**Site Boundary as shown on Architects Plans shown in red. Incorporates a large part of the Golden Lane Estate**

Extract from Plan Provided for Consultation by Hawkins Brown Architects

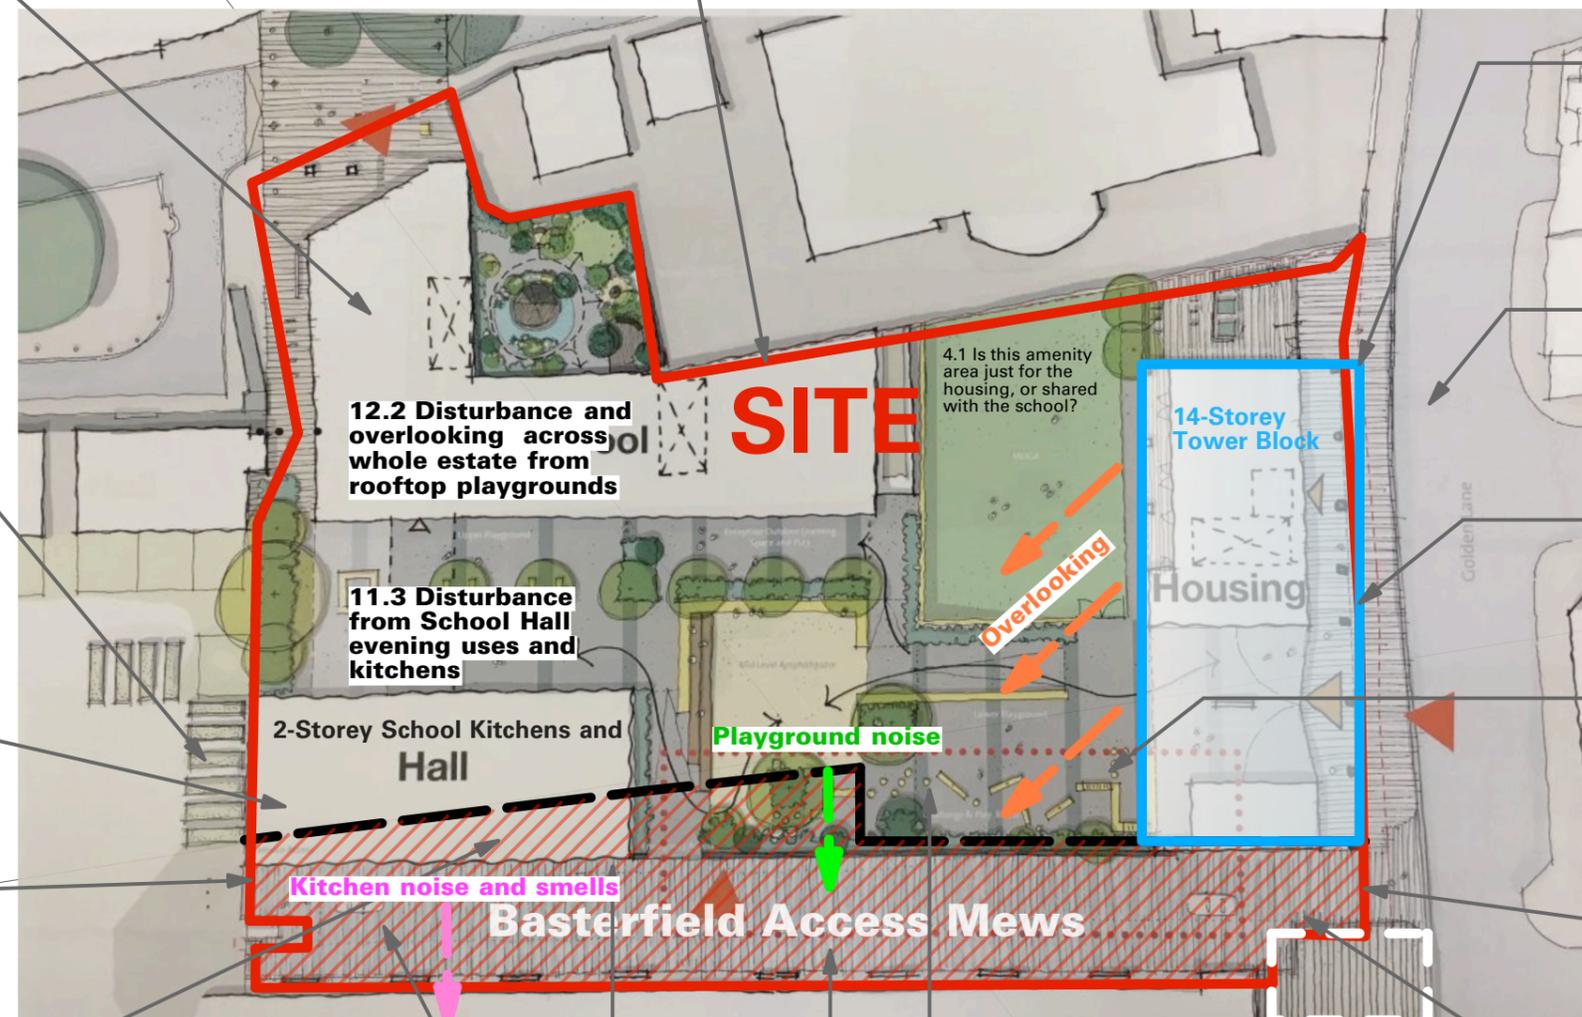
**3.1 School population increasing from 80 pupils to 458. (2 Form Entry) No demand in Finsbury or CoL. Moreland School opened at half capacity and spare capacity at Moreland will be sufficient until 2029.**

**Excessive number of housing units proposed. School is proposed as two form entry even though no demand has been demonstrated.**

**10.5 Finsbury Local Plan calls for public access to nature for this site to ease the pressure on Fortune Street Park**

**Resulting in massive over-development of site and pressure on Golden Lane Estate**

**10.1 Award-winning Golden Lane Allotments shaded by new double height Hall in mornings**

**10.3 School Hall should be part of School Building**

**10.3 Mature trees lost**

**11.1 Location of proposed Hall very close to Basterfield House and affecting design of Estate**

**9.1 Part of listed curtilage of GLE incorporated into school site**

**9.2 Amenity space and garages lost without consultation with GLE Residents**

**12.2 Disturbance and overlooking across whole estate from rooftop playgrounds**

**11.3 Disturbance from School Hall evening uses and kitchens**

**Kitchen noise and smells**

**8.2 No vehicular traffic (Other than emergency) allowed here at present**

**11.2 Noise and smells from school Kitchens. Windows of Basterfield single glazed with permanent vents, Cannot be closed off.**

4.1 Is this amenity area just for the housing, or shared with the school?

**3.3 Proposed 70 housing units. Density higher than London Plan policy**

**5.1 Finsbury Local Plan shows this area as suitable for 4-6 storeys, not 14 storeys.**

**2.4 New tower block (blue) is "wall" along Golden Lane blocking views**

**6.1 New tower block overlooks Estate. Potentially bigger scale than Great Arthur House**

**2.3 New tower block comes close to Stanley Cohen House and dominates the listed Estate**

**8.1 Private Basterfield Access Mews (Hatched) has been incorporated into the RCS Site and is proposed access for school playground and kitchens.**

**12.1 Noise from school playgrounds very close to single glazed rooms of Basterfield House**

**8.3 Red Hatched Area shows roadway - upkeep is paid for by GLE**
